UNITED STATES
NUCLEAR REGULATORY COMMISSION
WASHINGTON, D. C. 20555

Docket Nos. 50-329/330

SUBJECT: HYDROLOGIC ENGINEERING INPUT TO THE MIDLAND SER

HYDROLOGIC ENGINEERING INPUT TO
THE MIDLAND PLANT UNITS 1 AND 2 SER
DOCKET NUMBERS 50-329 AND 50-330

Figure 2.4.1 Hydrologic Features

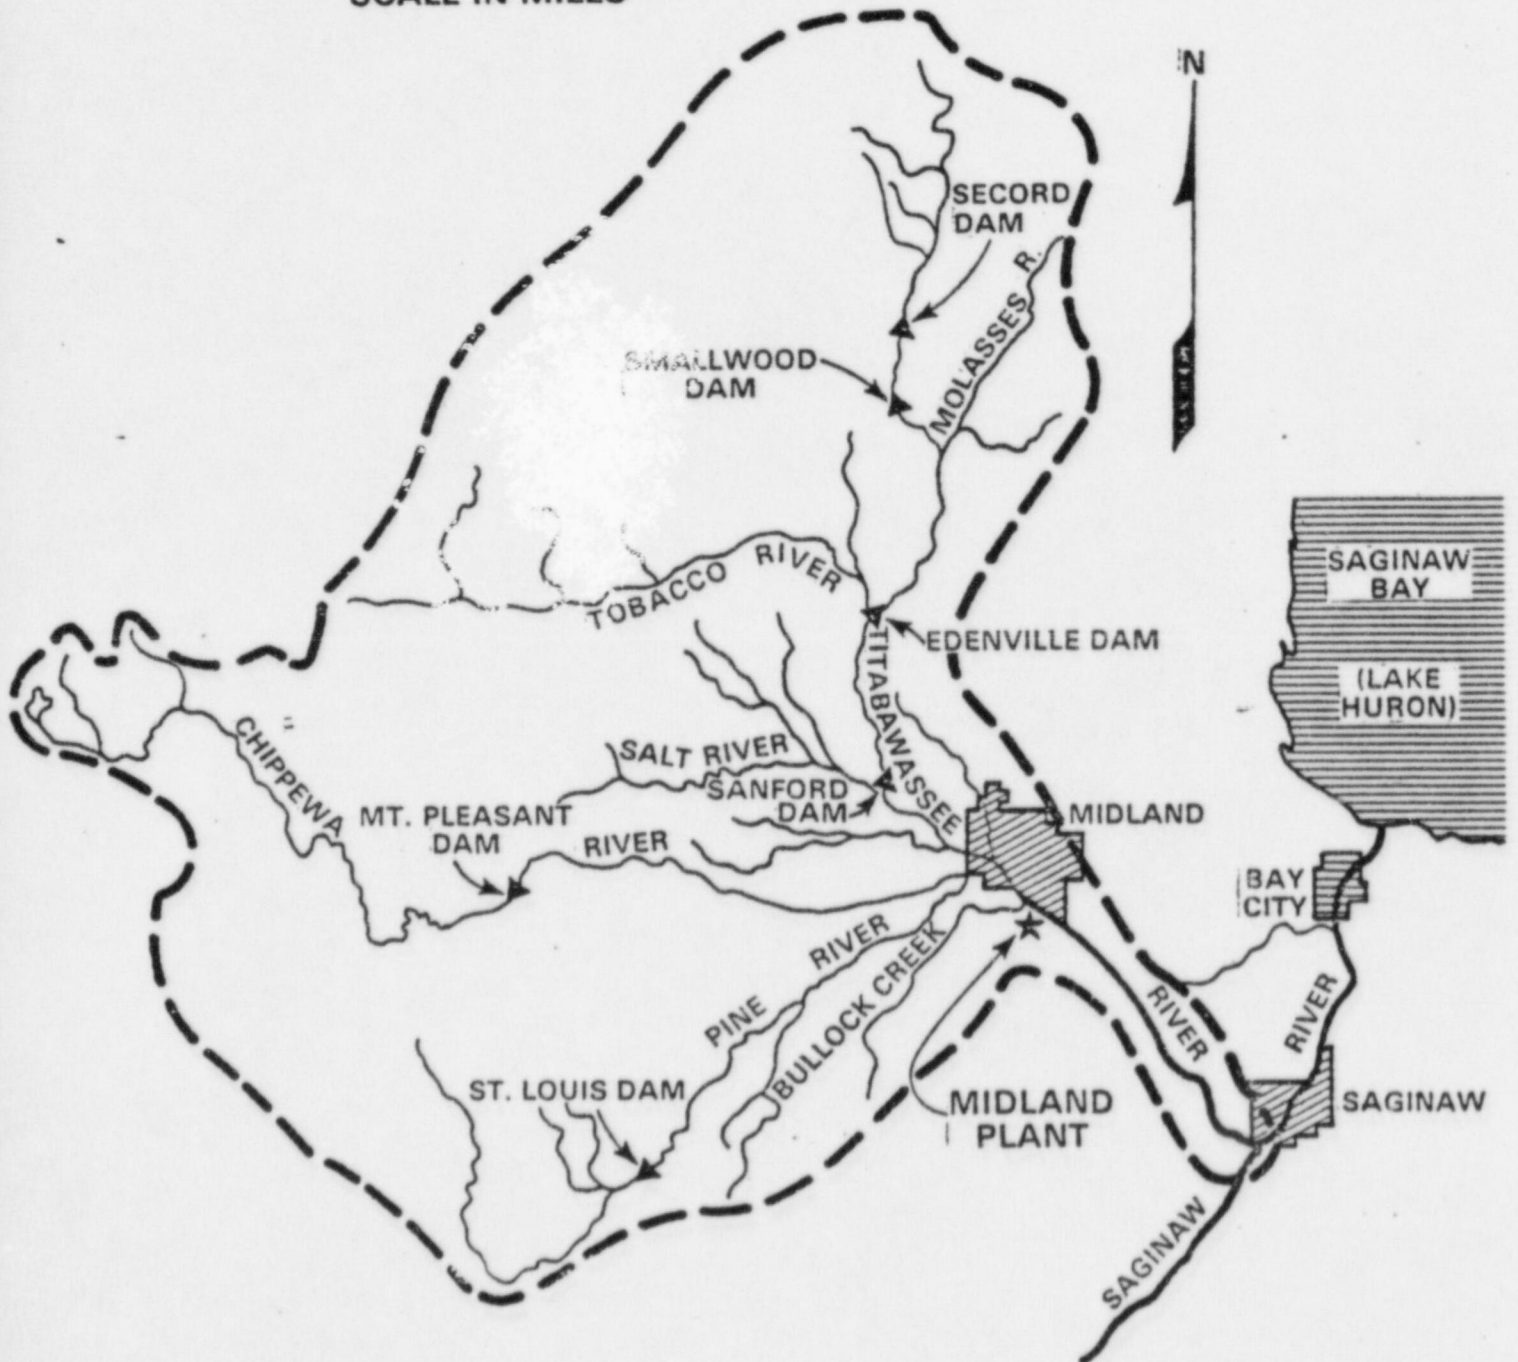
there it meanders in a southeasterly direction for a distance of about 85 mi until it empties into the Saginaw River. About 22 mi downstream of its confluence with the Tittabawassee, the Saginaw River flows into Lake Huron. The drainage area of the Tittabawassee River above the Midland Plant encompasses about 2400 square miles (mi²). Figure 2.4.1 shows the drainage basin and other hydrologic features of the Tittabawassee River.
